From: Piergiacomì Sud Newsletter <newsletter=piergiacomì.com@mail251.atl101.mcdlv.net> **On Behalf Of** Piergiacomì Sud Newsletter
Sent: 03 April 2018 8:53 AM
To: Sales <Sales@somersetsolders.com>
Subject: PRODUCT UPGRADE - DP MANUAL DEPANELING PLIERS

New Product upgrade: DP SERIES

old version of DP SERIES

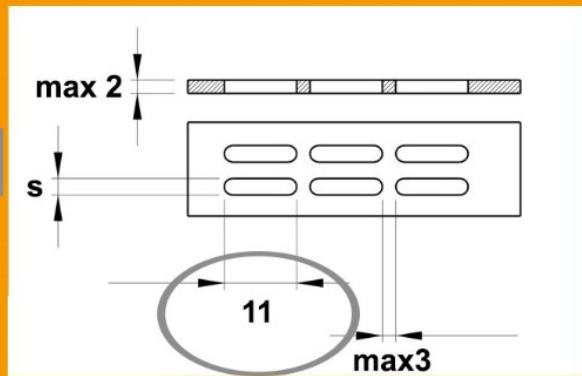
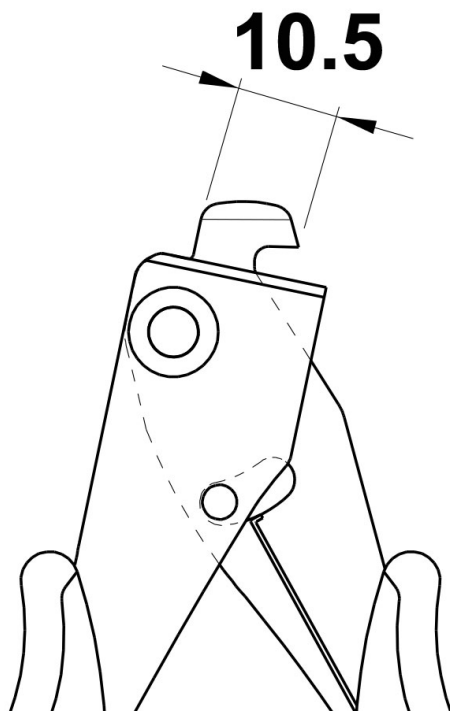
In order to improve the efficiency of our products, we are glad to inform you that in a short time the following products **DP15N-DP18N-DP20N-DP23N-DP24N-DP25N** will be supplied with an improved head profile as shown in the above picture.

The new version's head can be inserted in smaller tab

The reduced dimensions of DP head will allow the depaneling of small sized tab

Thanks to the new head shape it is even easier to drop off the cut part from the tool.
